## Why are there two accumulators for the 2000–2007 Ford Focus?

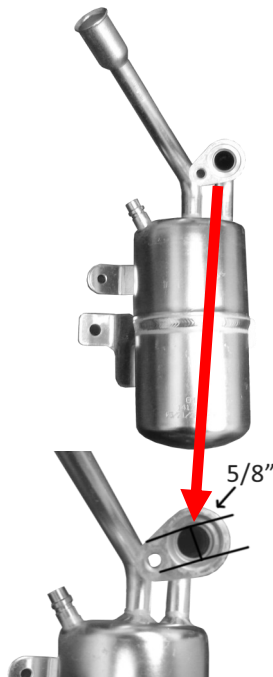
You may have noticed two gpd listings for the accumulator on a Ford Focus and wondered, why? When the vehicle was released, the Ford Focus was originally fitted with the accumulator (gpd #1411664). This accumulator features a  $\frac{5}{8}$  inch inlet hole size on the suction side, which transfers refrigerant to the compressor.

Over the course of the vehicle's life, the accumulator and suction hose were redesigned. The new accumulator (gpd#1411867) now features a  $\frac{3}{4}$  inch hole size.

Due to the age of the vehicle, the most common accumulator found on this vehicle is the second design (gpd #1411867). If there is a Ford Focus with the earlier design, the accumulator may not have been replaced yet. It is best practice to update the system to the latest accumulator (gpd #1411867) and suction hose.
